Site Address: 2751 WEST RIVER DR SAC St: BLD#20
Parcel No: 274-0440-001 BLDG. #20

Nature of Work: BLDG. # 20, TYPE A, NEW APT. WITH GARAGES

Architect's Supplemental Instruction No. 00007

Date: 8/20/2003
 Project Name: Villas at Riverbend
 Project Number: 6510001
 Subject: Clarifications

Floor/Ceiling Assembly Clarification:

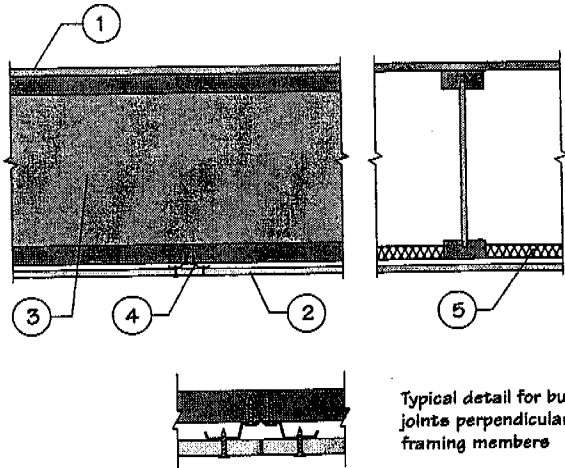
Test # G & H USDA - 11 ST

1-1/2" lightweight concrete (100 p.c.f.) over 3/4" plywood over TJI at 24" with RC channels and one layer 5/8" type x gyp board.
 3" glass fiber batts insulation required at vinyl floors. STC = 58. IIC = 50 at vinyl. 77 at carpet and pad.

Roof/Ceiling Assembly Clarification: No STC required

Test # 2002 CBC, Table 7C - #21

Wood trusses at 24" with 1/2" plywood sheathing and two layers 5/8" type x gyp.
 Must use two layers gyp even with RC channels for fire rating. (PFC 4354)
